**AGENDA
MAPLE PLAIN PLANNING COMMISSION
MEETING
MAPLE PLAIN CITY HALL
APRIL 7, 2016
7:00 PM**

Request by Proto Labs for Site Plan Review and Variance to Allow an Expansion of the Existing Parking Lot for the Property Located at 5540 Pioneer Creek Drive

To: Planning Commission
From: Mark Kaltsas, City Planner
Meeting Date: May 5, 2016
Applicant: Proto Labs
Owner: Proto Labs
Location: 5540 Pioneer Creek Drive

Request:

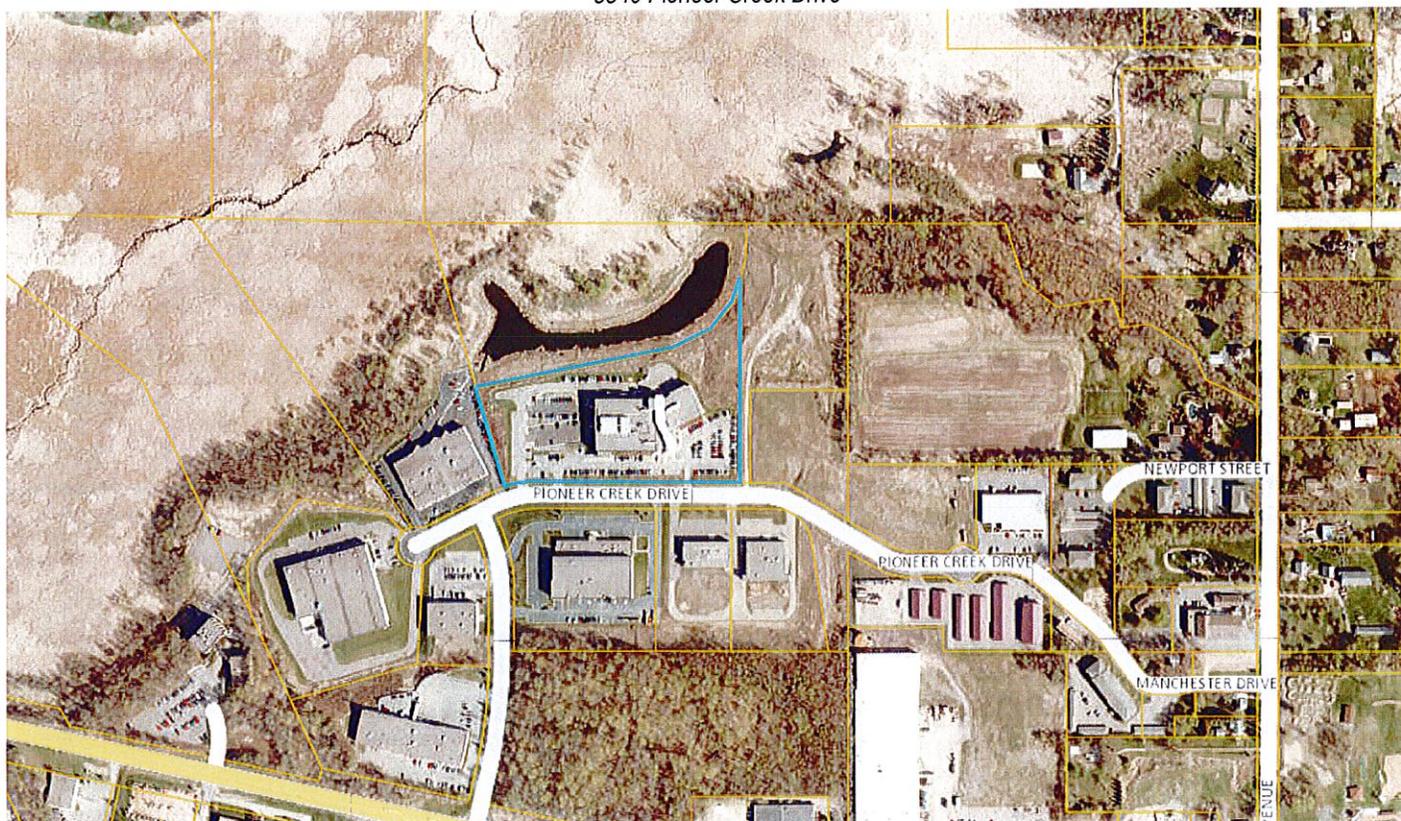
The proposed parking lot expansion consists of an additional 31 or 40 spaces depending on which option the applicant chooses. The applicant has provided two possible scenarios for consideration (Option A – Spaces or Option B – 40 spaces). There are currently 327 parking spaces on this site. Based on the recently completed interior improvements, the applicant is 7 spaces short of meeting the City's ordinance requirements. The applicant has provided a breakdown of the existing and proposed building uses so that the City can review the required parking. The summary of required parking is as follows:

The proposed expansion of the existing parking area will allow the total site parking to exceed the minimum required. In addition to reviewing the minimum parking space requirements, the City reviews all other applicable design criteria. Design criteria considered during the review of the proposed parking expansion includes; setbacks, parking space design, parking lot lighting, storm water management, drainage and grading.

In the I- Industrial Zoning District, parking is permitted to be located anywhere on the lot as long as it does not encroach into any designated buffer yards. The current parking lot has a setback of approximately 15 feet from the rear property line. The proposed parking spaces will be setback approximately 10 feet from the rear parking lot. The proposed parking lot meets applicable setbacks.

The applicant is seeking a variance from the stipulated parking space size requirements. The applicant is proposing to construct 18 foot deep parking spaces in lieu of the required 20 foot deep parking spaces. The remainder of the site currently has 18 foot deep parking spaces. The City previously granted a variance to the applicant to allow 18 foot deep parking spaces on this site. The City could consider granting a variance to allow 18 foot deep parking spaces across the entire lot. Parking spaces which are 18 feet deep and have an overhang area at the back of the space are common and would be considered “standard” for most applications. The proposed parking spaces back up to an open area and not to additional parking spaces; therefore, the spaces would meet the typical standard.

The Fire Department reviewed the proposed parking expansion and did not believe it would have a negative effect on their ability to service this property.

Parking Lot lighting shall be arranged as to deflect light away from any adjoining residential zone or from the public streets. There are three (3) existing light poles located along the north property line adjacent to the existing parking lot. The lights are a shoebox type fixture with no part of the light extending below the bottom of the fixture housing (cut-off type fixture). The applicant has provided the City with the applicable photometric plan and light cut sheets. The City has reviewed the information provided and found the existing poles to meet the City's lighting standards.

The City's Engineer has reviewed the proposed parking lot expansion relating to storm water, grading and drainage. The City's Engineer had no formal comments relating to the proposed plans. The applicant will be constructing two retaining walls in order to accommodate the new parking spaces. The City will require additional details relating to the proposed retaining walls prior to construction. The applicant did submit the plans to the Pioneer Sarah Creek Watershed Commission. It was determined that the proposed parking space expansion (Option A or B) did not trigger any additional stormwater requirements.

Staff is seeking a recommendation from the Planning Commission for the requested Site Plan Review and Variance. Should the Planning Commission make a positive recommendation to the City Council, it is recommended that the following findings and conditions be included:

1. The proposed site plan review and variance meets all applicable conditions, criteria and restrictions stated in the City of Maple Plain Zoning Ordinance.
2. The variance will allow all parking spaces on the subject property to be constructed to the following requirements:
 - a. Parking Space Depth – 18 feet
3. The City will require additional details relating to the proposed retaining walls prior to construction.
4. Any change to the interior use of the building may require additional review by the City. This includes
